FINAL DEVELOPMENT PLAN APPLICATION

CLAYCRAFT WAREHOUSE

Subject: Claycraft Warehouse- Final Development Plan Comments
City of Gahanna, Franklin County, Ohio
CEC Project 182-564

RE: Project 870 Claycraft Rd Final Development Plan Comments

DRAWING NO.:
C200

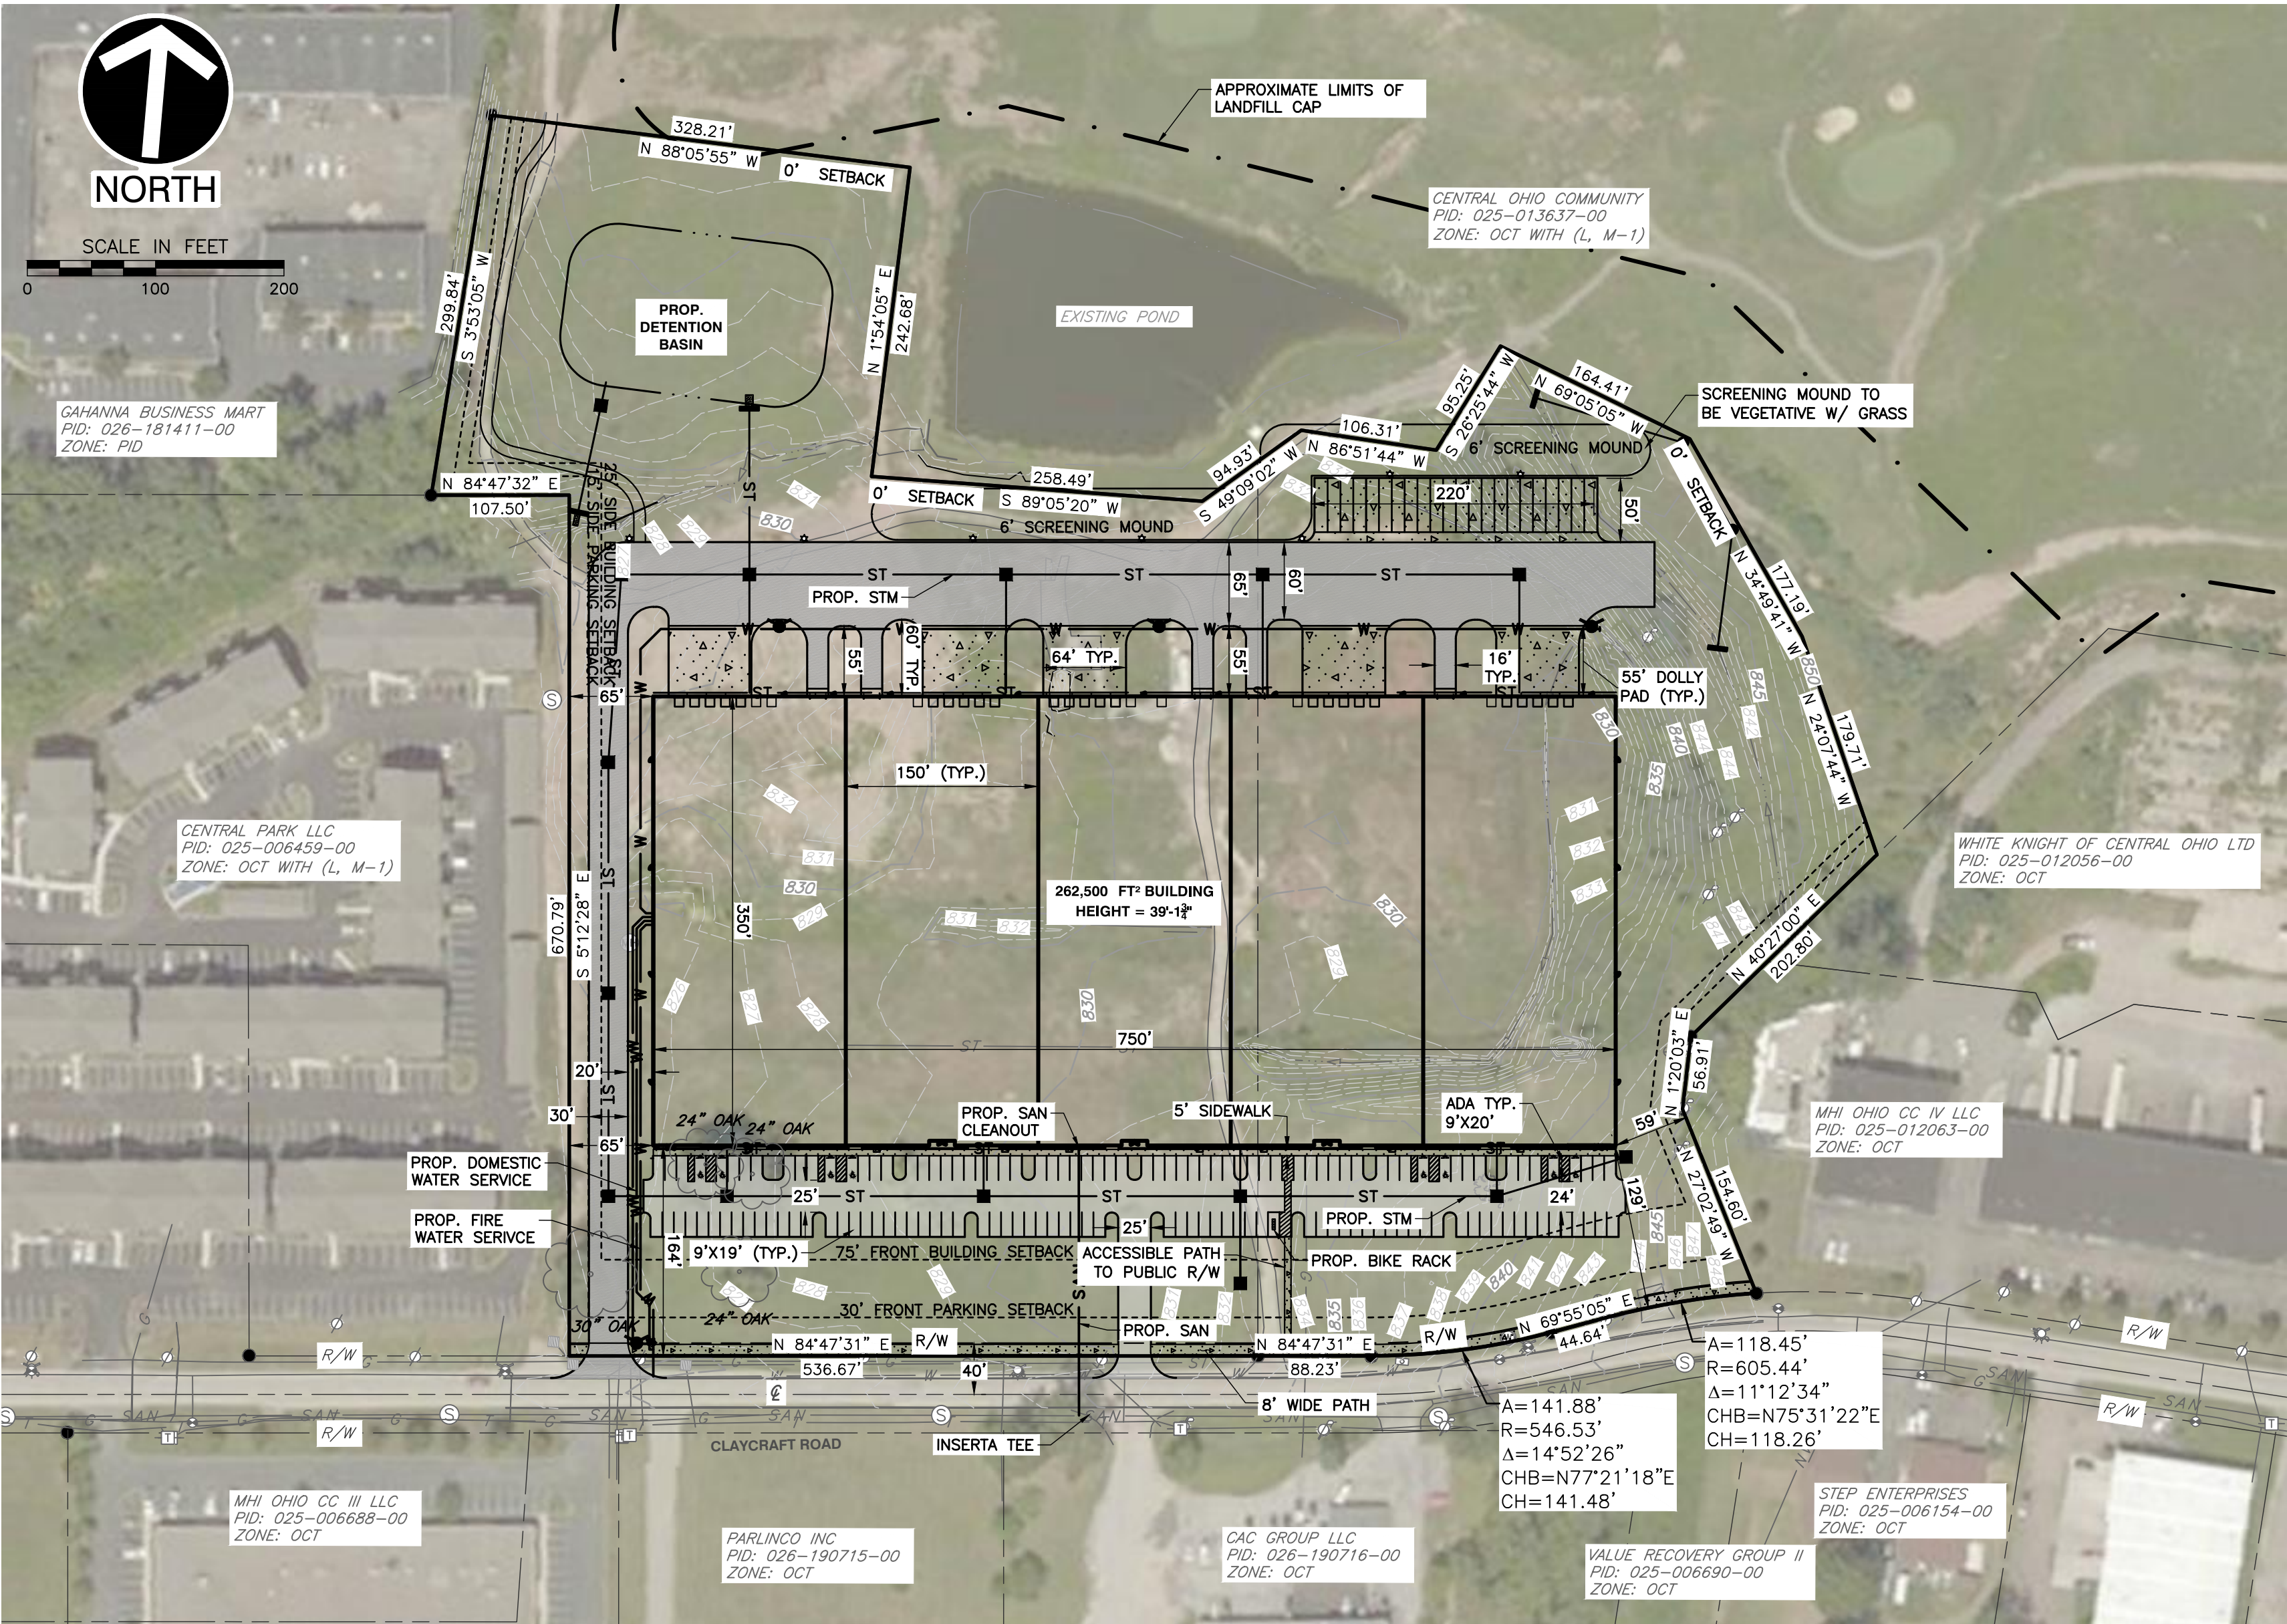
- Due to the project location, the owner/developer shall coordinate with the FAA for conformance to their guidelines and restrictions.
- The site is located near a former landfill. The site plan shall show the limits of the existing landfill cap. In addition, it should be noted that the Developer shall discuss with the seller any requirements that may be in place for development near the landfill.

8. Our office is in the process of adopting a complete streets policy. As a result, the development shall install a multi-use trail along the frontage of the development and provide a pedestrian route from the path to the building.

Multi Path & pedestrian route has been added to the plan.

CLAYCRAFT WAREHOUSE
GAHANNA, OHIO
LANDSCAPE PLAN

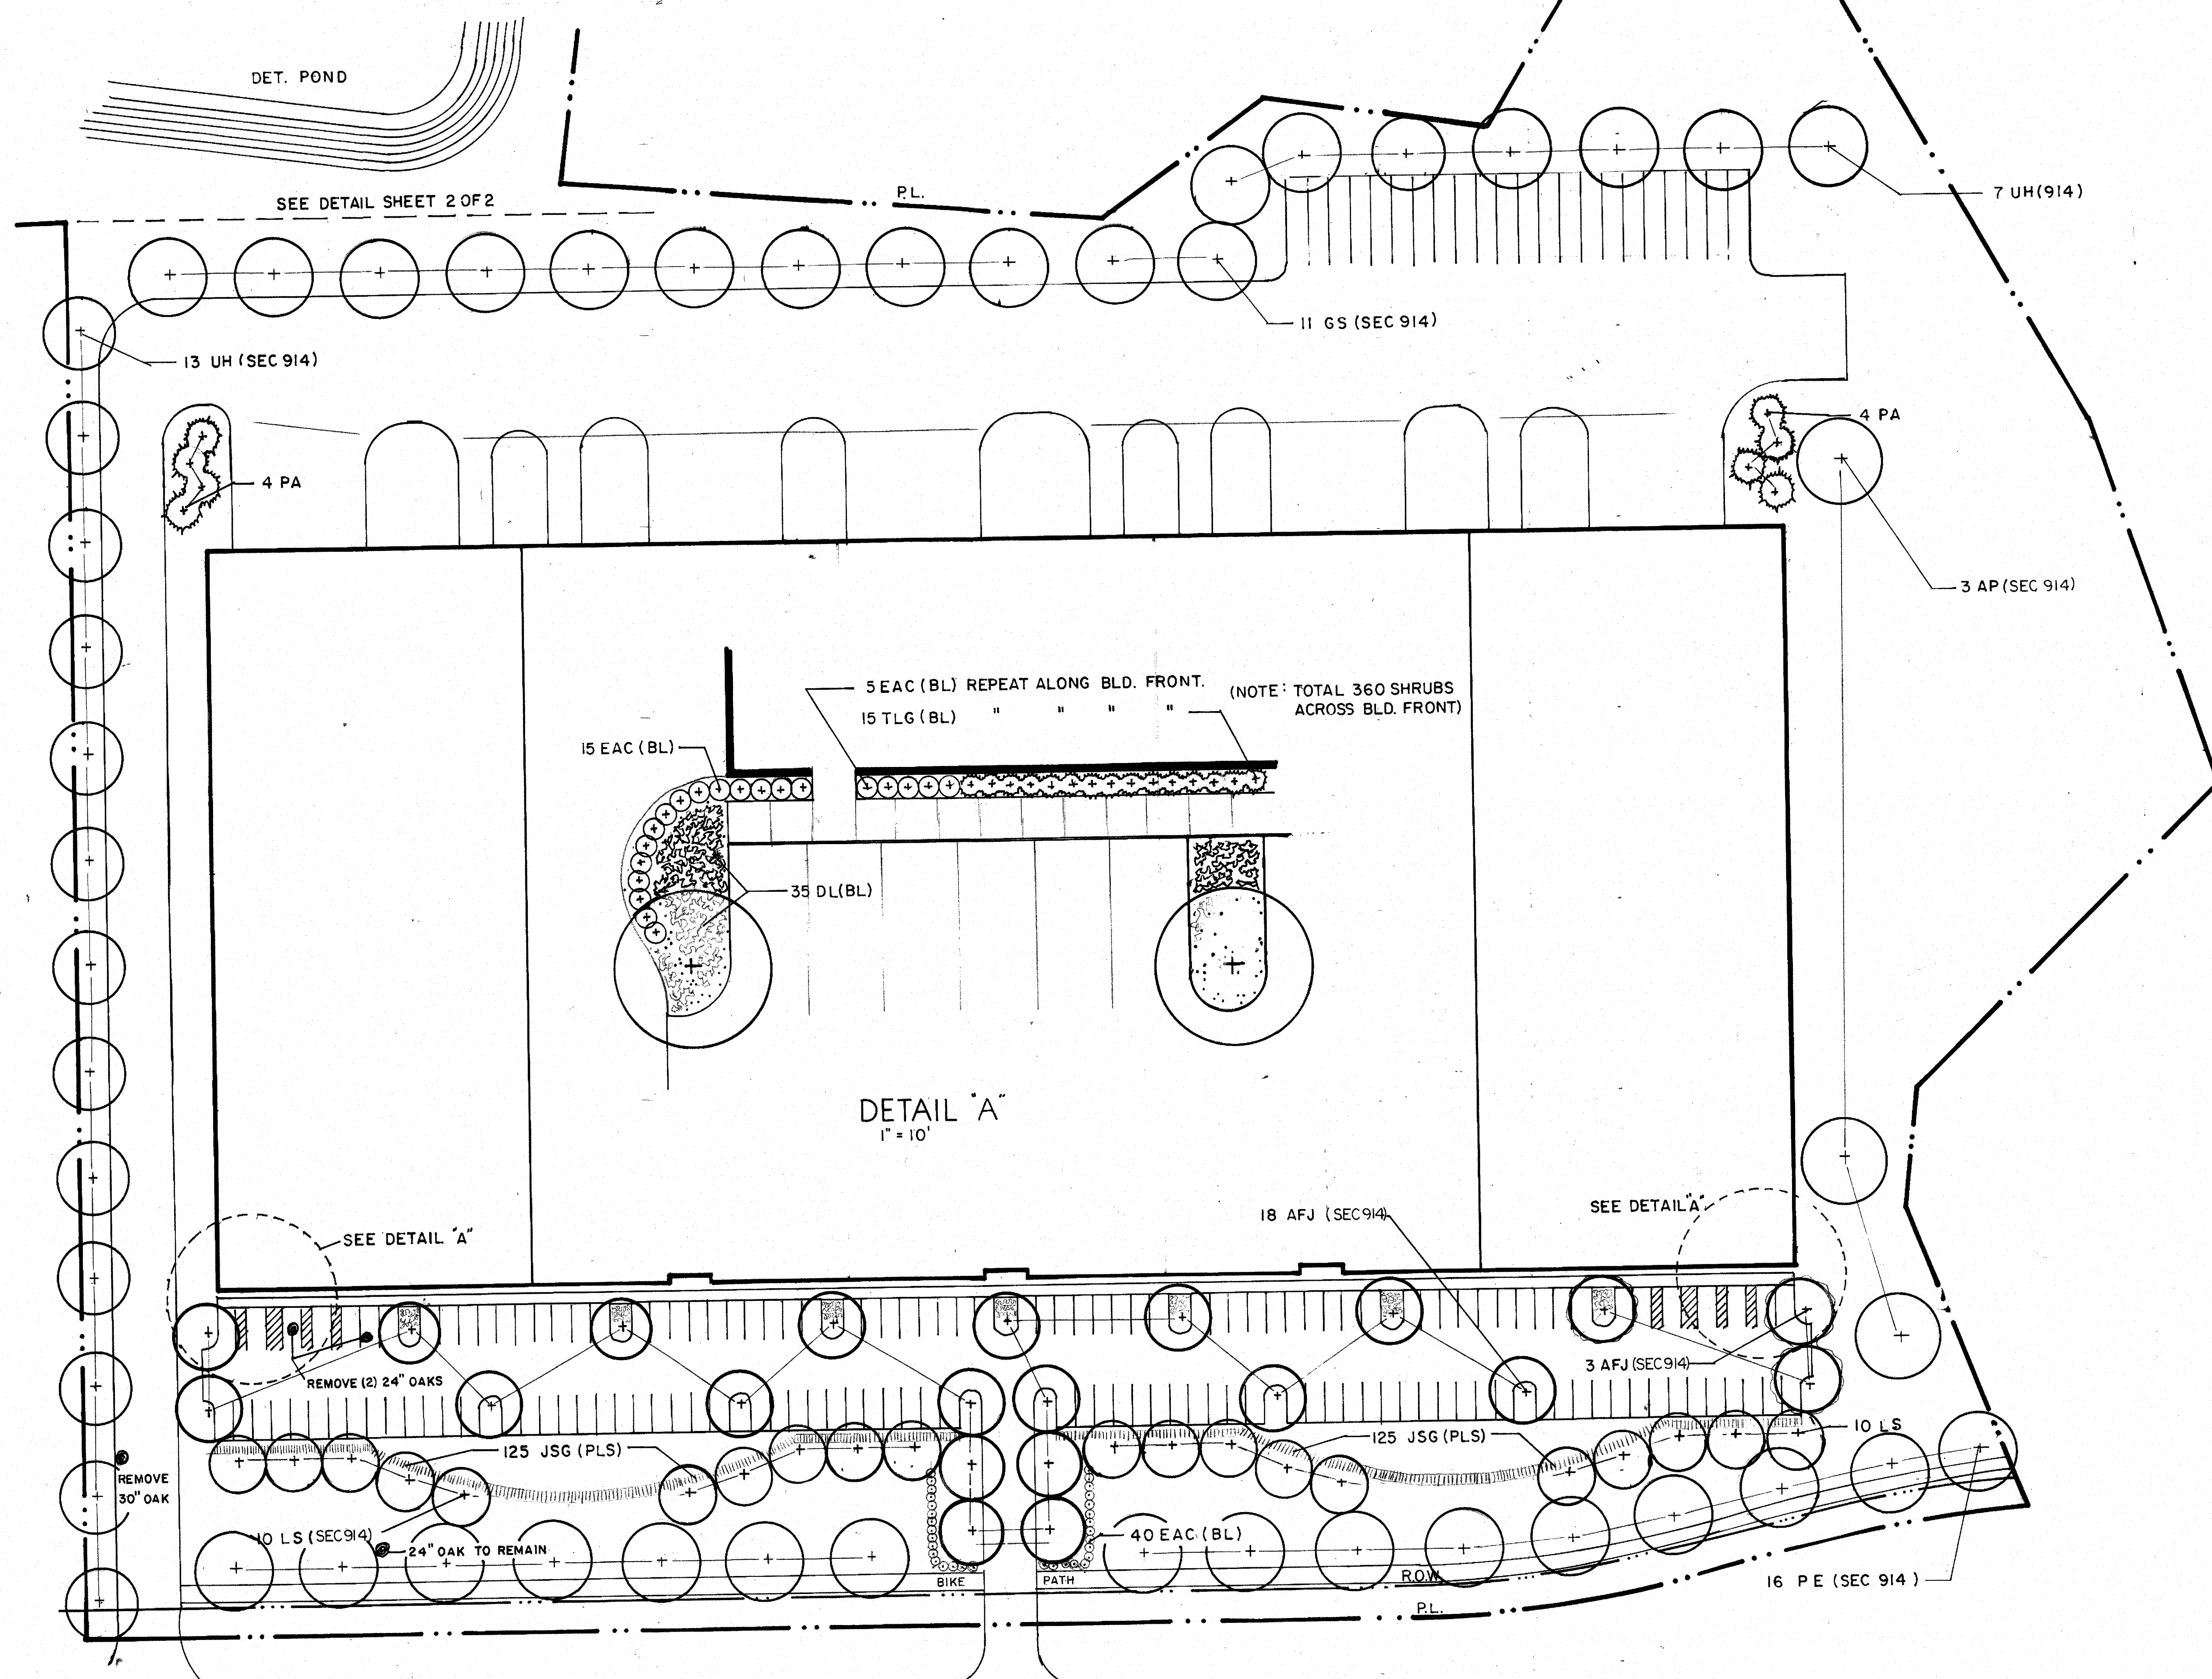
4. A 6' tall mound is shown the north side of the property to screen the loading areas. This meets the overlay requirements except the mounds are required to have adequate plant material to prevent erosion. Please revise the landscape plan accordingly.

12/10/18 - Response to comments indicates grass will be planted to meet this requirement. No issue with this, however, the landscape plan need to be revised to indicate what will be planted and where. Please revise the plan accordingly.

5. Chapter 914 requires 1 shade tree caliper inch per 1,000 square feet of impervious area. This requirement is separate from all other landscaping requirements. Based on the impervious amount, 418 inches of trade trees are required. Plantings are required to be between 1 1/2" and 2 1/2" in size. Please revise the landscape plan accordingly.

12/10/18 - Please be aware that a variance to chapter 914 is not possible. Variances may only be requested to the standards of chapter 1100. Chapter 914.05(c) allows for a fee to paid in lieu of onsite plantings. The fee is \$200 per inch.

Landscape plan revised to account for new variance request.

Variance request has been revised to Chapter 1100.
